**MAJOR PROJECT ASSESSMENT:
78-90 Old Canterbury Road, Lewisham
(MP08_0195)**

Director-General's
Environmental Assessment Report
Section 75I of the
Environmental Planning and Assessment Act 1979

January 2012

Figure 12: Floor space ratio for the site and adjoining sites within the McGill Street precinct under Marrickville LEP 2011 (Base image source: Marrickville Council, 2011)

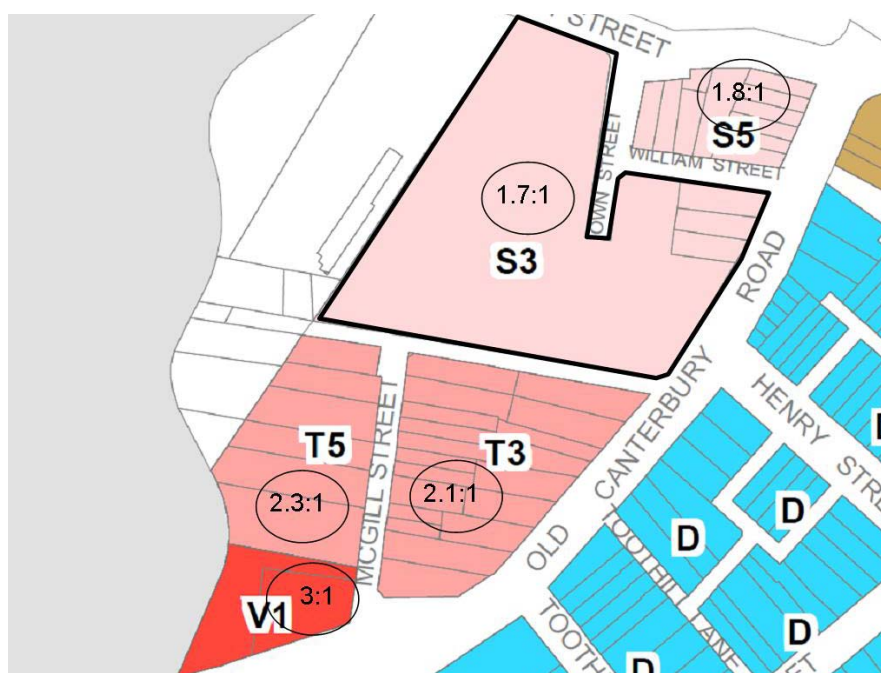
The Marrickville LEP 2011 provides a maximum floor space ratio of 1.7:1 for the site (**Figure 12**). The proposal seeks approval for an FSR of 3.04:1 which exceeds the LEP control by approximately 79% (approximately 17,660m² additional GFA).

The FSR control within the LEP was derived from the McGill Street Precinct Masterplan, which provides an indicative maximum GFA for the site of 22,237m². The GFA of the proposal is 39,896m².

Figure 14: Cross section of Building G showing the relative height of 4 storeys at the Old Canterbury Road frontage (Base image source: Proponent's PPR)

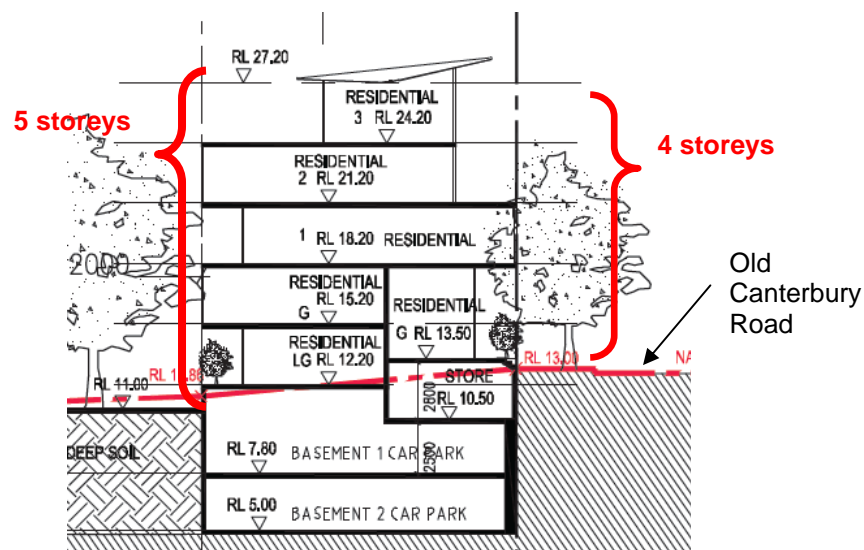
The proposed building envelopes at the Old Canterbury Road frontage are 4 to 5 storeys in height. The Old Canterbury Road frontage is considered to be the most sensitive location as the proposal will be highly visible from the low scale residential area on the eastern side of Old Canterbury Road.

While the proposed buildings have a height of 5 storeys, they will present a height of 4 storeys to the Old Canterbury Road frontage (refer to **Figure 14**). This provides a scale appropriate for a main road and a suitable transition from the single storey development on the eastern side of Old Canterbury Road and the higher buildings towards the light rail corridor. It is noted that the building height in this location is consistent with the Masterplan.

Figure 15: Proposed cross section showing the relationship between Building D and Longport Street (Base image source: Proponent's PPR)

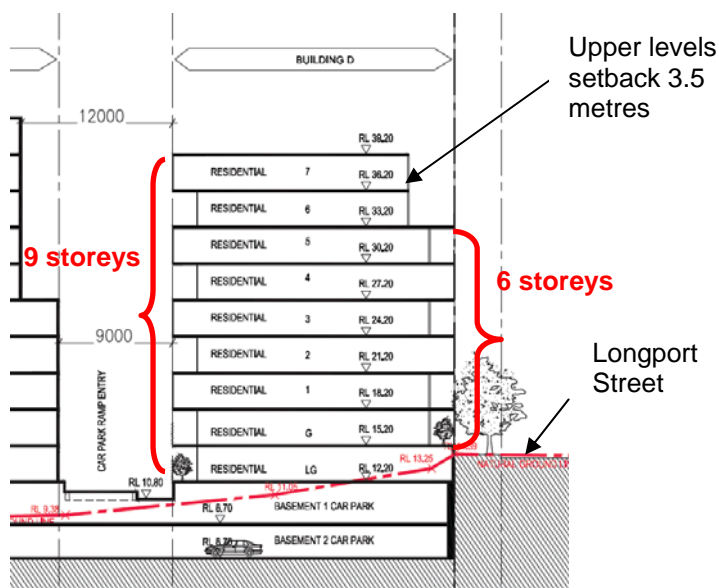
The department considers that the proposed building height and form is appropriate in this location. Given that the lower level does not extend above footpath level and the upper two levels are setback from the levels below, the department is satisfied that the proposed building, while being 8 to 9 storeys in height, will present as a 6 storey building to most ground level vantage points along Longport Street.

Figure 16: The height relationship of Building A with proposed plaza and with open space (Base image source: Proponent's PPR)

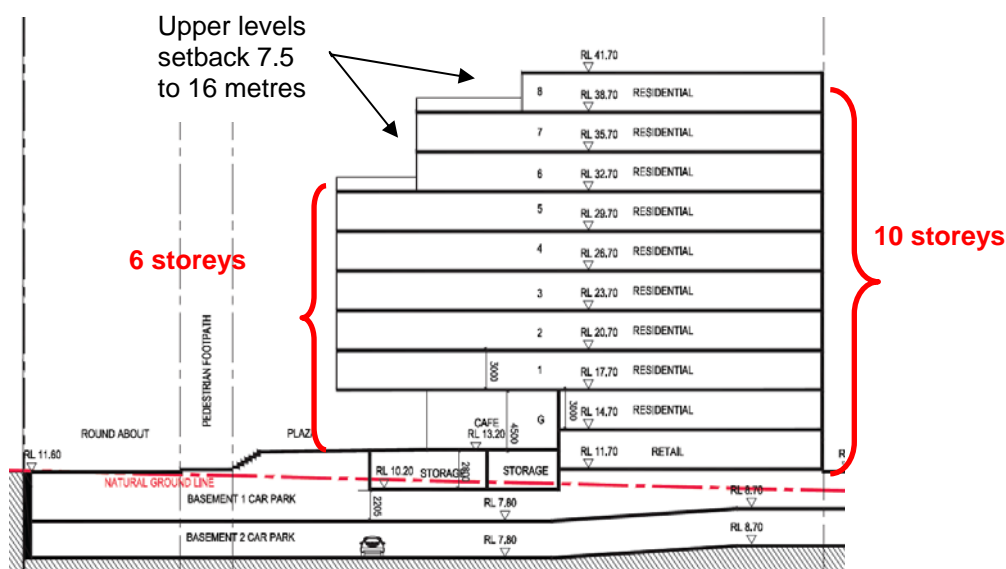
The department considers that the 5 storey height of Building C is appropriate as the 7 storey components of the building are setback 13 metres from the levels below. The department also supports a higher building height adjacent to the light rail stop and considers that Building A provides an appropriate height of 7 storeys in this location with the upper 3 levels setback between 7.5 metres and 16 metres from the levels below. Further, given the raised plaza provided adjacent to this building the building will read as 6 storeys from the main area of open space. Refer to **Figure 16**.

The department considers that heights of 5 and 6 storeys provide an appropriate scale and defined edge to the open space. Overshadowing impacts of the additional height are discussed in the following section.

Figure 17: Overshadowing caused by the proposed building envelopes in the Concept Plan (Source: Proponent's PPR)

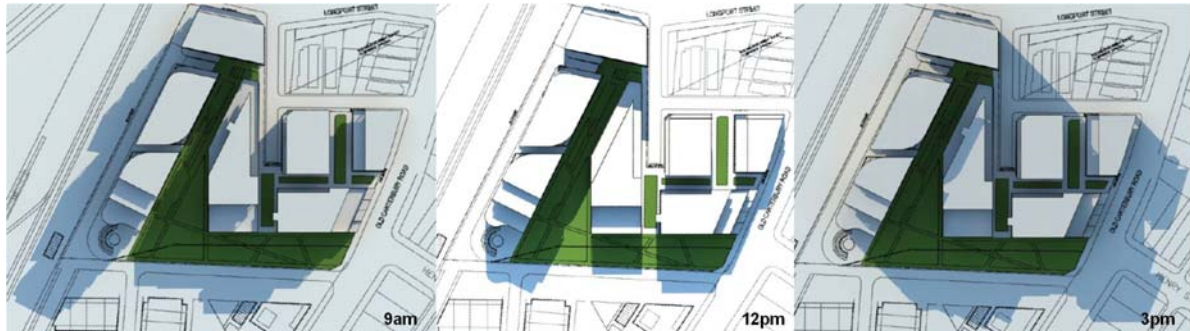
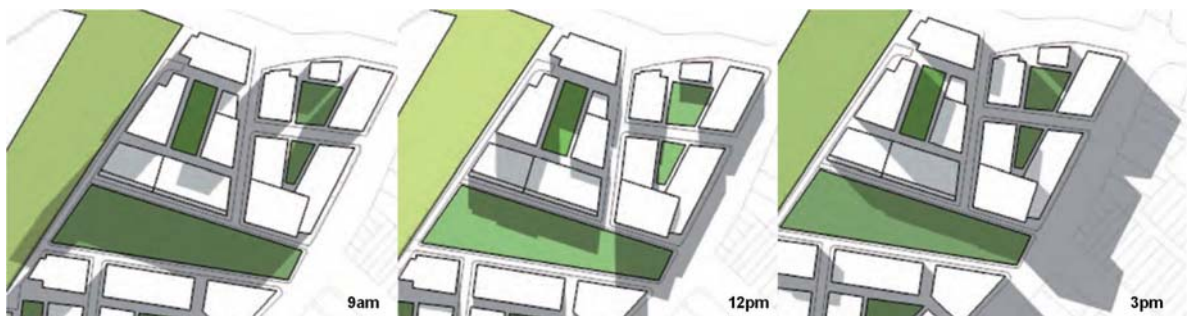
As demonstrated in **Figure 17** and **18**, above, the extent of shadow created by the proposed building envelopes, although greater than the shadows caused by the Masterplan envelopes, will have minimal adverse impacts on surrounding properties to the south of the proposed open space or to the east of Old Canterbury Road. Shadows will be increased to the light rail corridor in the morning, but this area will not be shadowed by the proposal from about 10am onwards.

The main area of increased impact is on the proposed public open space area, which will be significantly overshadowed between 9am and 3pm, midwinter. While the separation between buildings A, C and E allows some sunlight to reach the open space in the middle of the day (primarily between 10am and 1pm), the open space area will be largely overshadowed during the morning and afternoon in mid winter. The shadow diagrams prepared by Hassell (**Figure 18**), however demonstrate that the Masterplan building envelopes will afford increased solar access to the open space.

Figure 19: Comparison of proposed publicly accessible open space, private open space and through site links between the Proposal (left) and the Masterplan (right) (Base image source: Proponent's PPR)

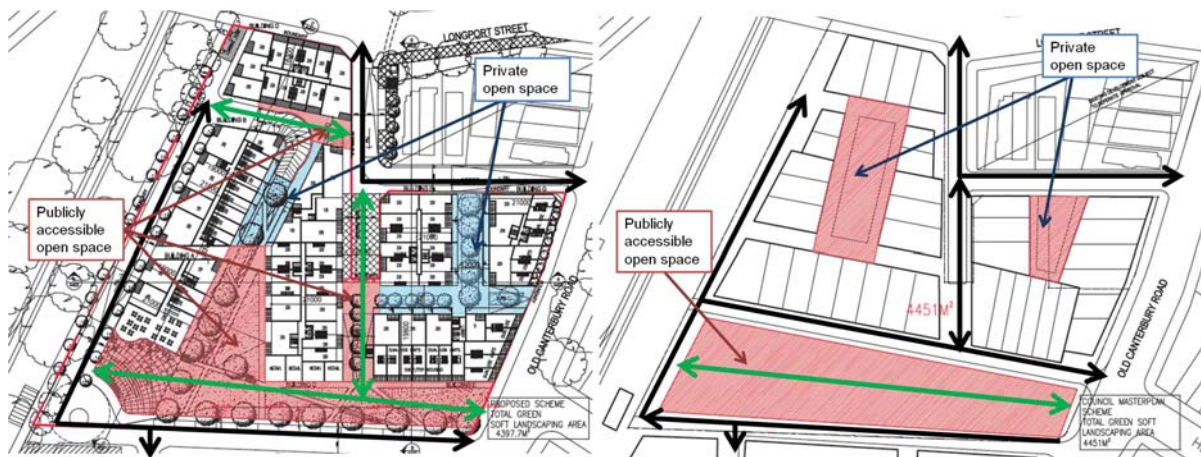
- the proposal does not provide for the extension of Brown Street or a new east-west road to the north of the main area of open space;
- the proposed main area of open space is narrower, but opens up to a larger more functional space in the western portion of the site, including a large area between Buildings A and C and paved plaza (which is partially covered by the building above); and
- the proposal involves narrower areas of private open space in the same general location as the Masterplan.

The department considers that the proposal provides an equivalent level of site permeability to the Masterplan. Although the proposal does not include the road to the north of the proposed open space or the extension of Brown Street in accordance with the Masterplan, publicly accessible landscaped open space and through site links are provided in these locations to maintain pedestrian permeability throughout the site.

Figure 20: Building Separation

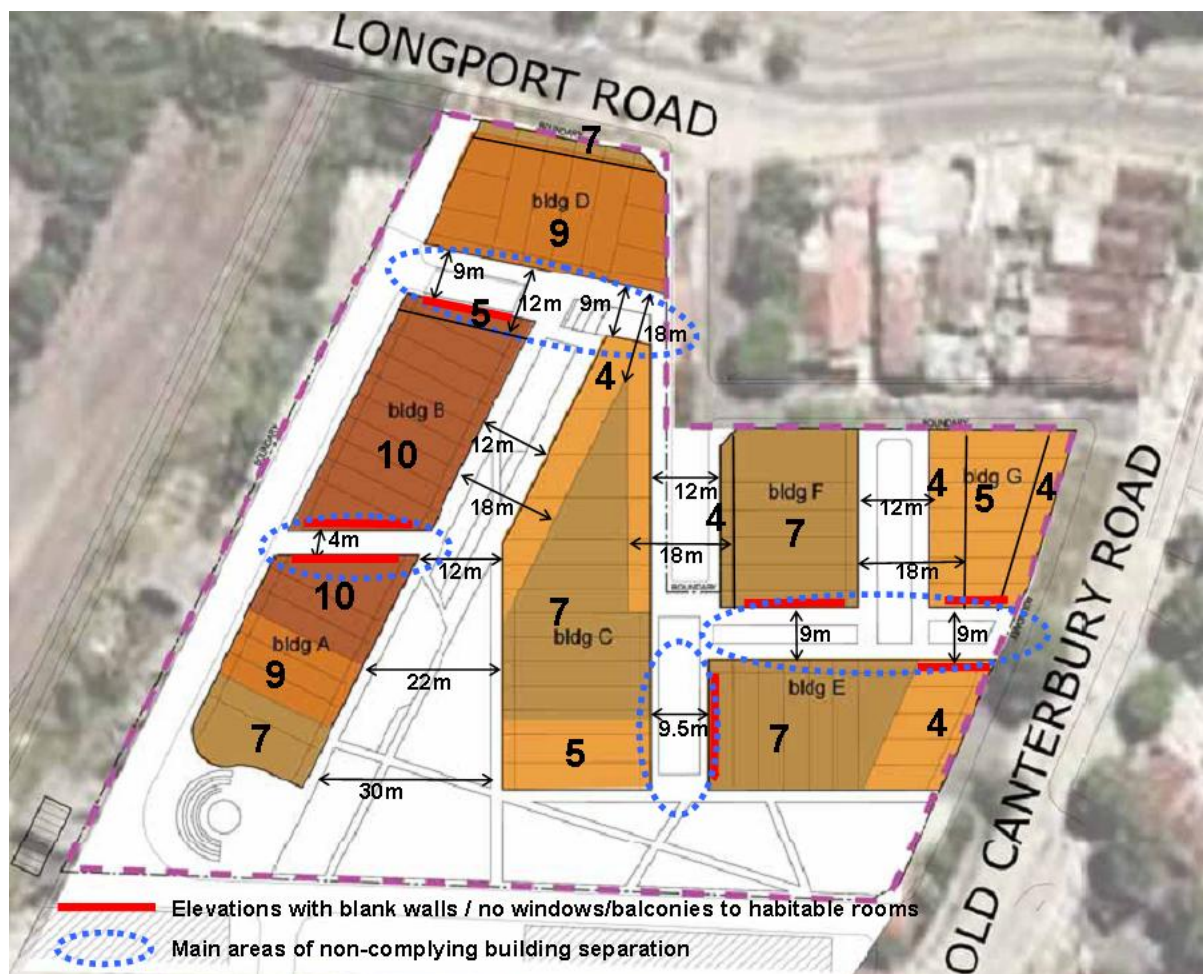
The proposal does not comply with the recommended minimum separation in the following locations as outlined in **Figure 20**:

Blank walls and/or elevations with no balconies/windows to habitable rooms are proposed in these locations (as highlighted in red in **Figure 20**) in order to address visual and acoustic privacy between apartments.

The department recommends that building separation is increased in the following locations:
